PREVOST

**SAFETY
RECALL**

SR21-301

DATE:	June 2021	SECTION :	18 BODY
SUBJECT:	USSC WHEELCHAIR OCCUPANT RESTRAINT SYSTEM REWORK

Figure 1

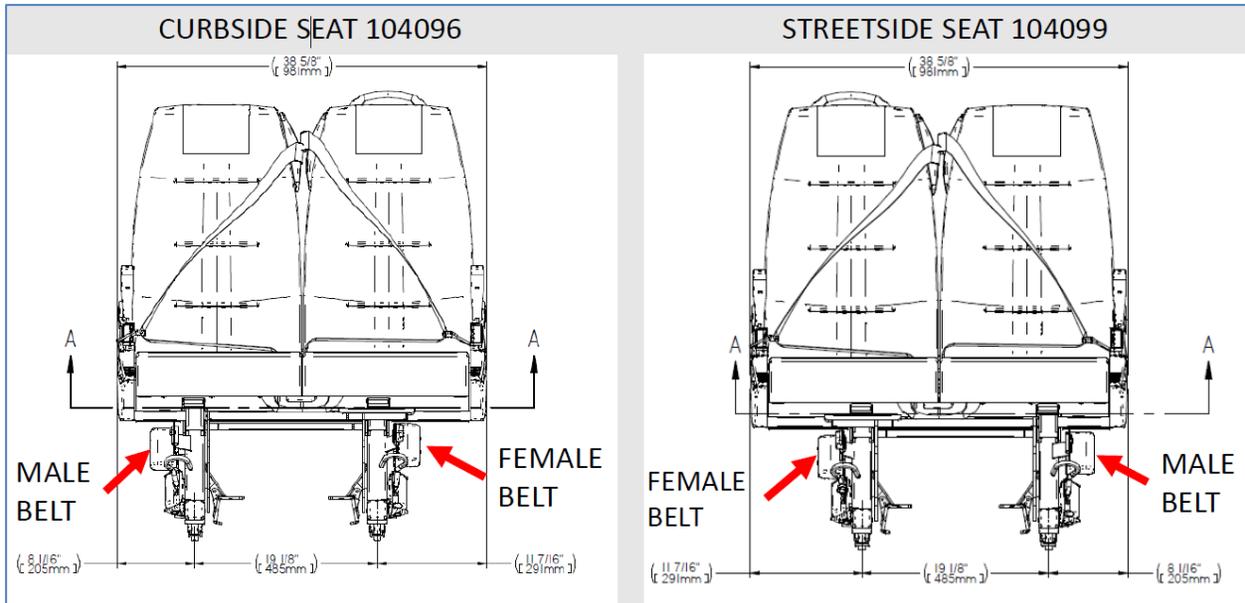
1. Rework wheelchair occupant restraint system. More precisely, the male belt located on the wall side (Figure 1).

Figure 2

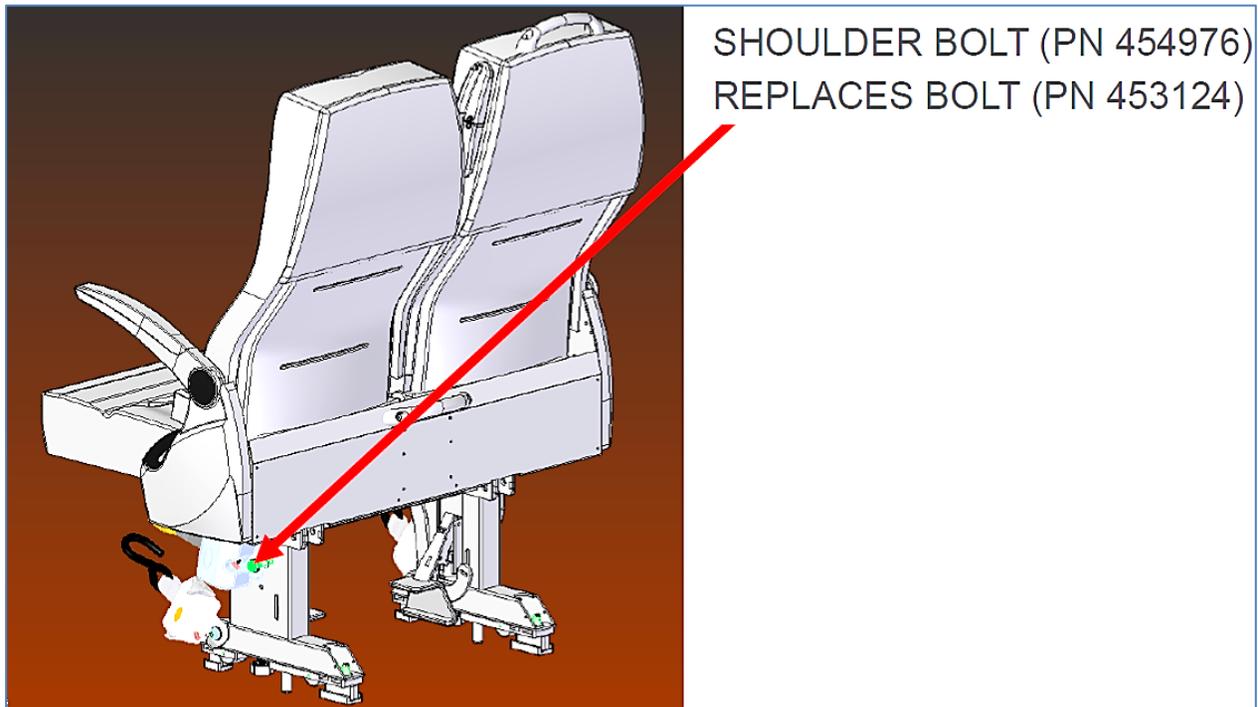
2. Replace existing bolt with shoulder bolt 454976 (Figure 2 & Figure 3). TORQUE 10-12 LBS-FT.
